NEBRASKA PUBLIC POWER DISTRICT
DOCKET NO. 50-298
COOPER NUCLEAR STATION
AMENDMENT TO FACILITY OPERATING LICENSE

Amendment No. 70
License No. DPR-46

ATTACHMENT TO LICENSE AMENDMENT NO. 70

Remove the following pages of the Appendix "A" Technical Specifications and replace with the enclosed pages. The revised pages are identified by Amendment number and contain vertical lines indicating the area of change.

Figure 3.11-2a 7x7 Fuel

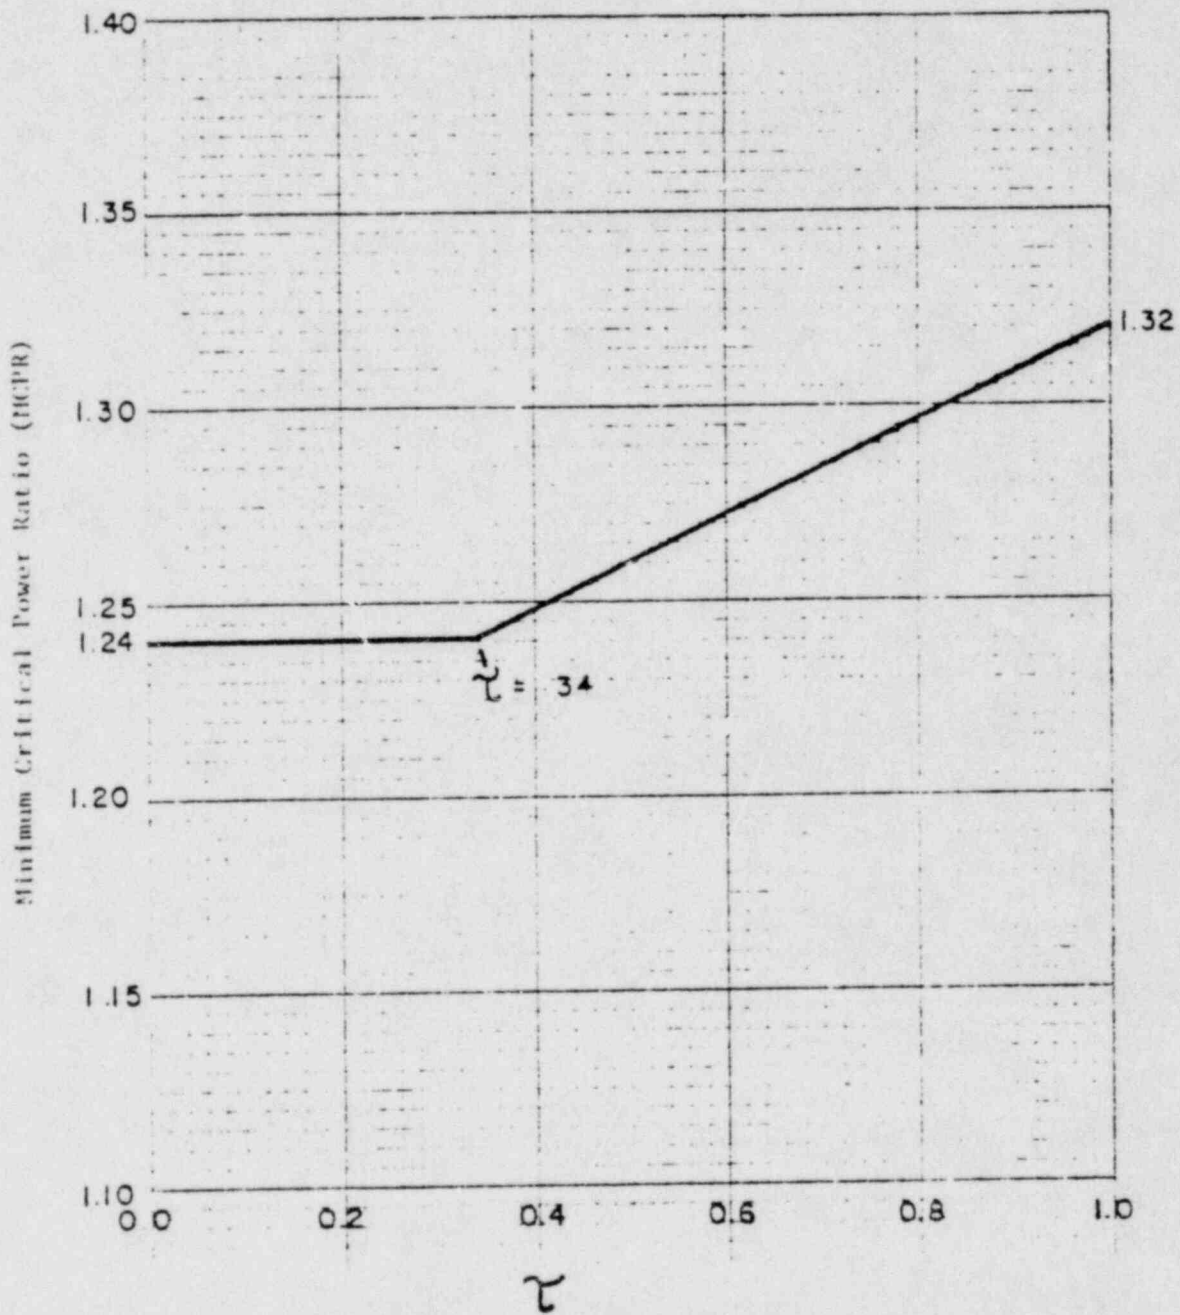
During steady state power operation the MCPR for each type of fuel at rated power and flow shall not be lower than the limiting value shown in Figure 3.11-2. If, at any time during steady state operation it is determined by normal surveillance that the limiting value for MCPR is being exceeded, action shall then be initiated within 15 minutes to restore operation to within the prescribed limits. If the steady state MCPR is not returned to within the prescribed limits within two (2) hours, the reactor shall be brought to the Cold Shutdown condition within 36 hours. Surveillance and corresponding action shall continue until the prescribed limits are again being met.

(based on tested measured scram time
as defined in Reference 9)

Figure 3.11-2b Sx8 Fuel

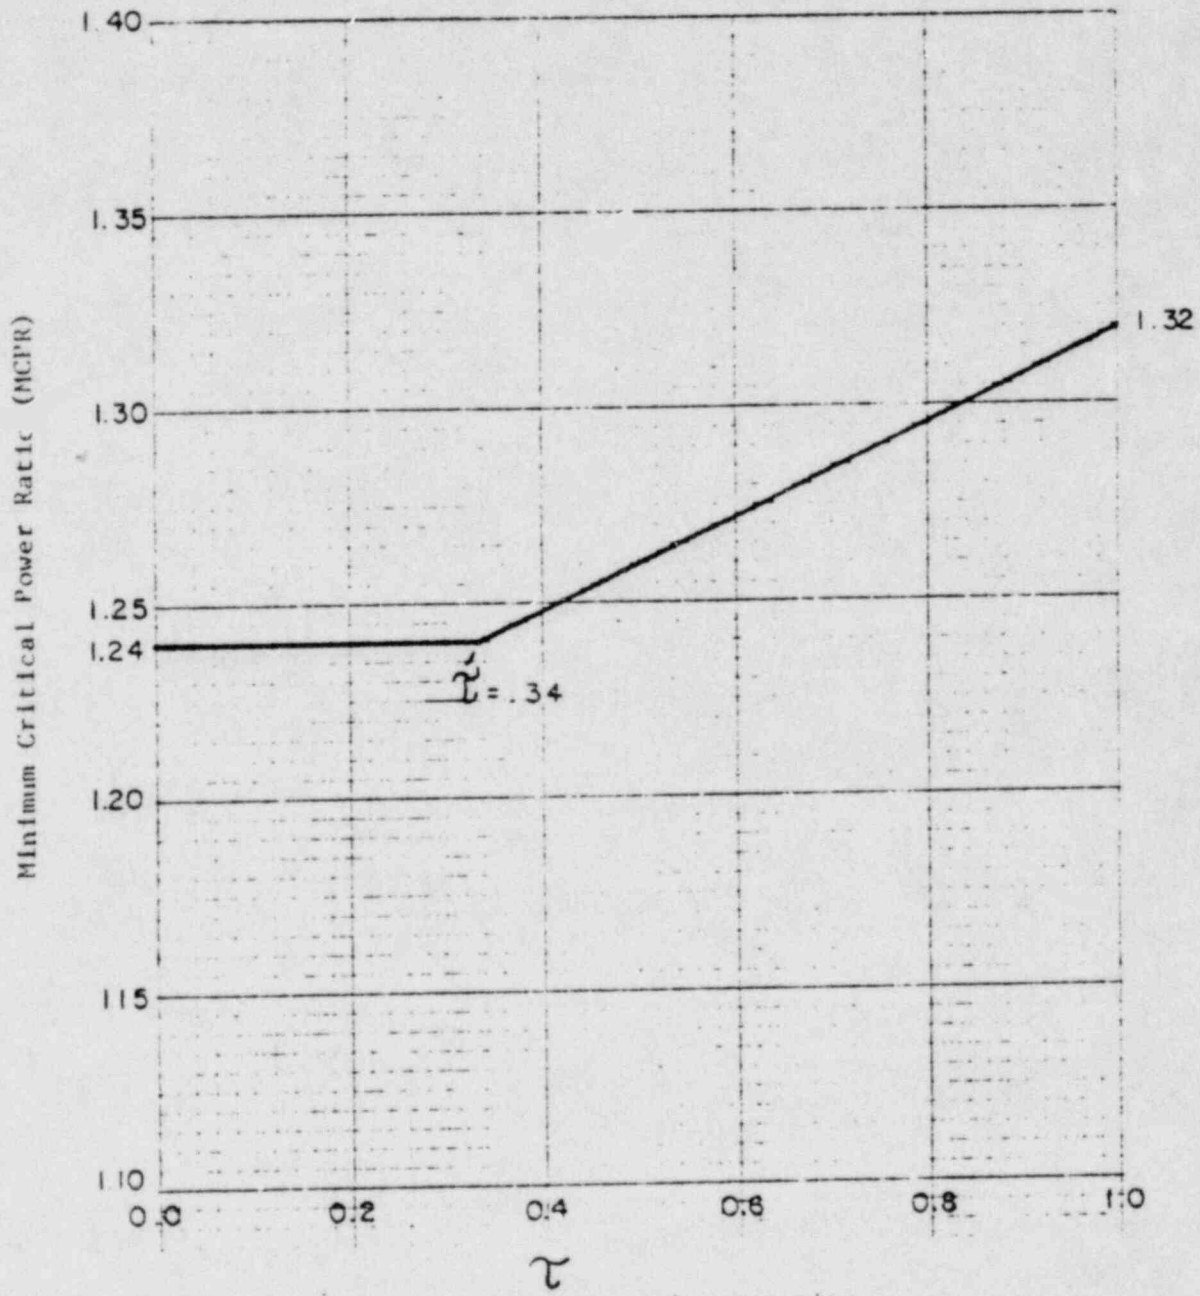
(Based on tested measured scram time as defined in Reference 9)

Figure 3.11-2c 8x8R Fuel

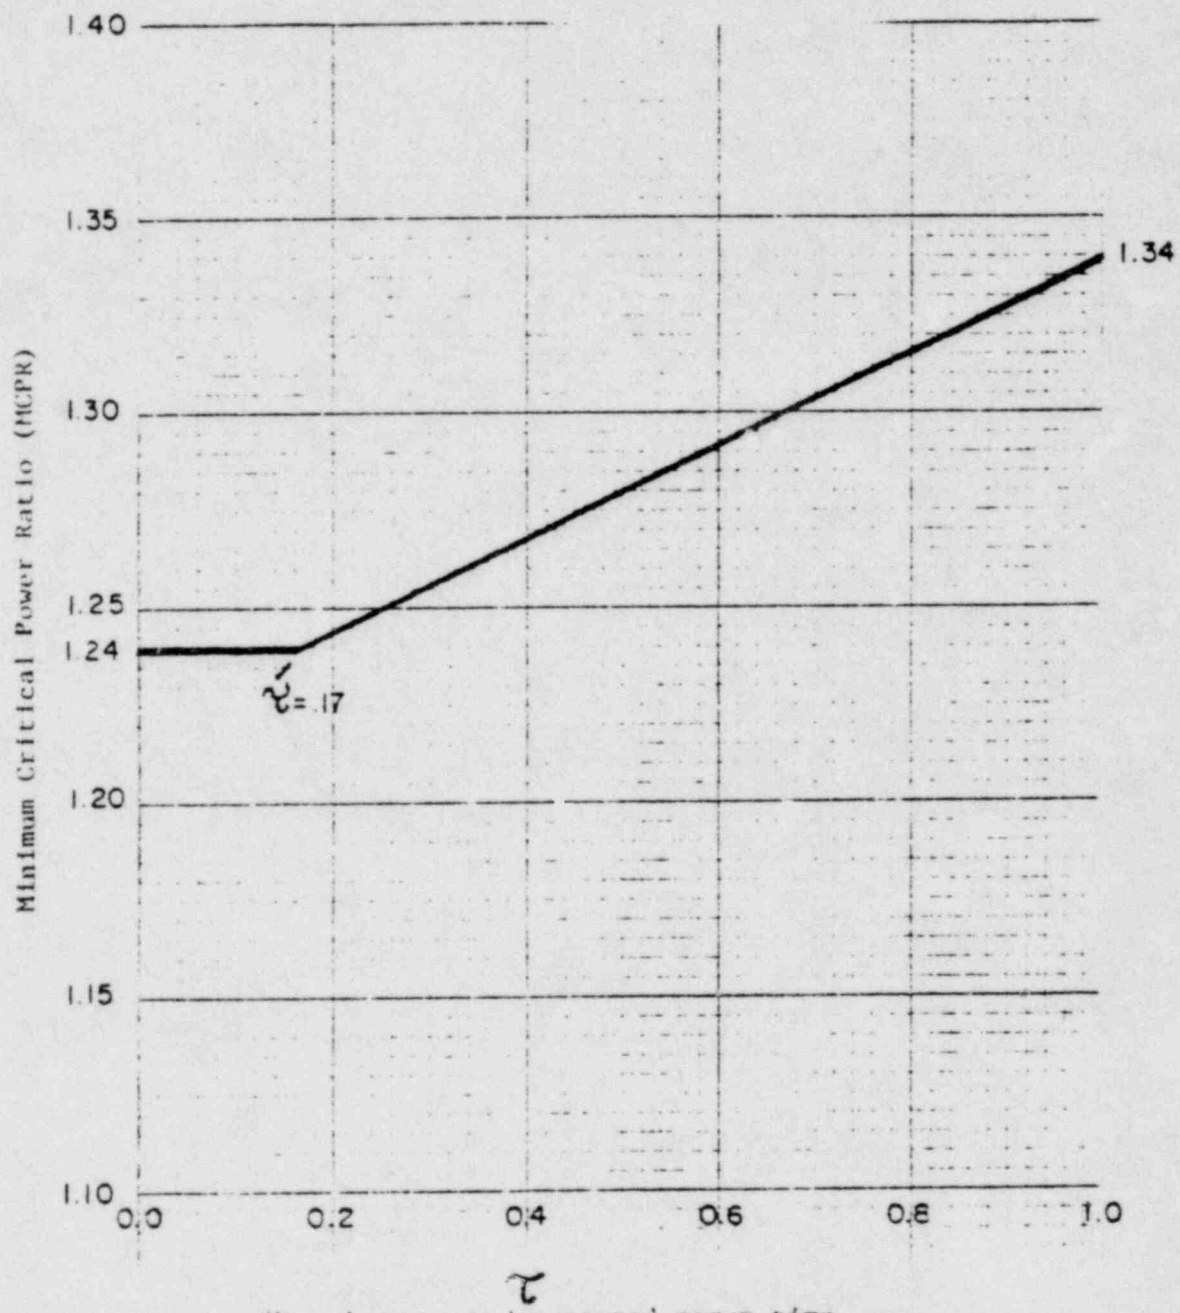
(Based on tested measured scram time as defined in Reference 9)

Figure 3.11-2d P8x8R Fuel

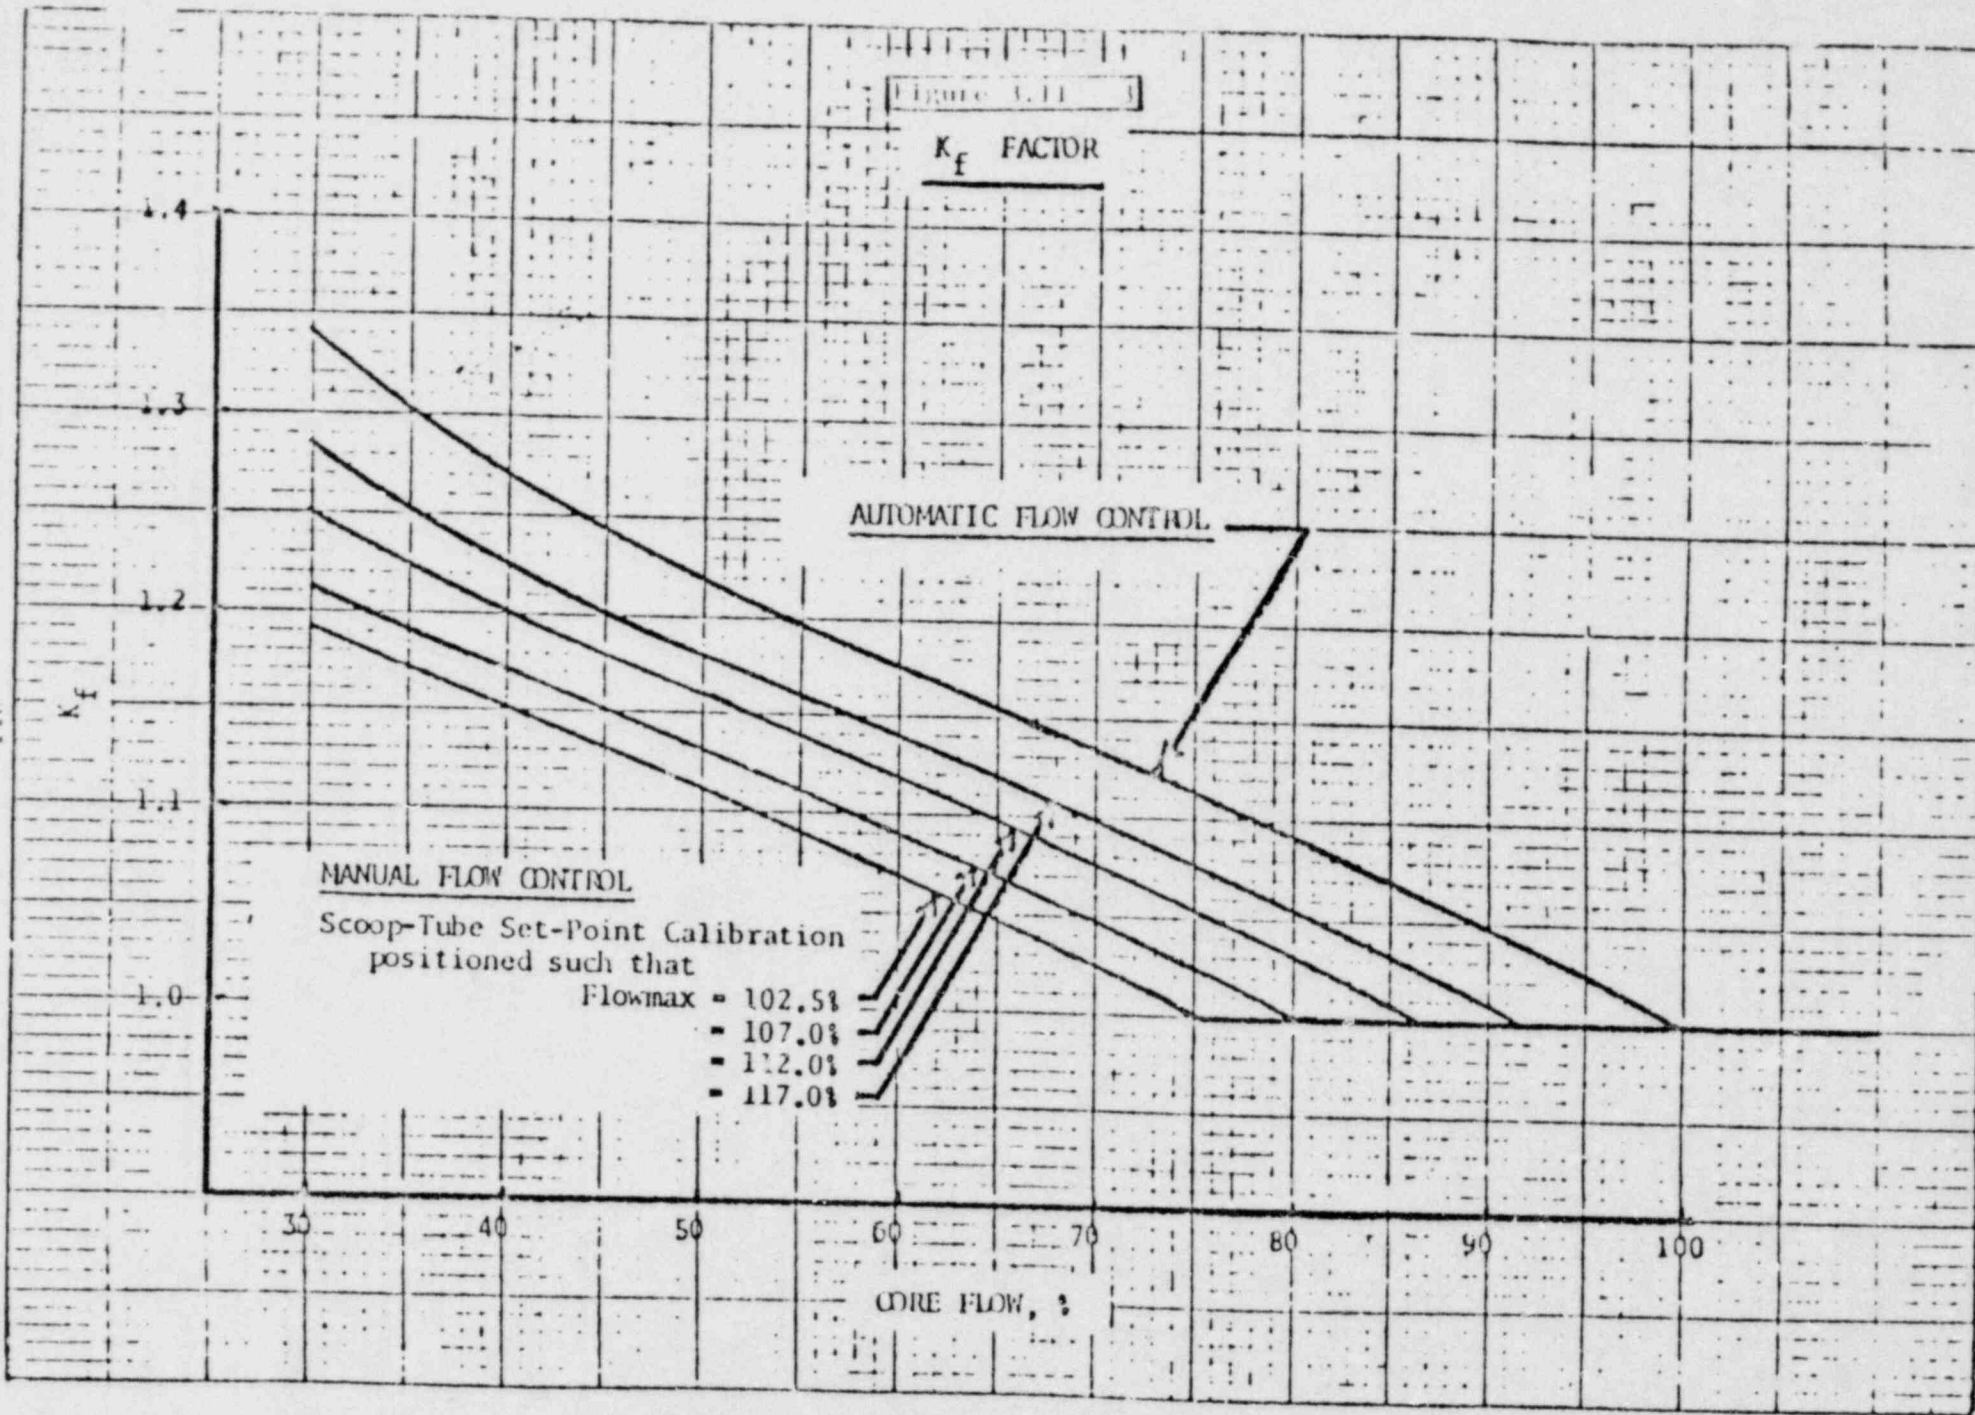
(based on tested measured scram time as defined in Reference 9)
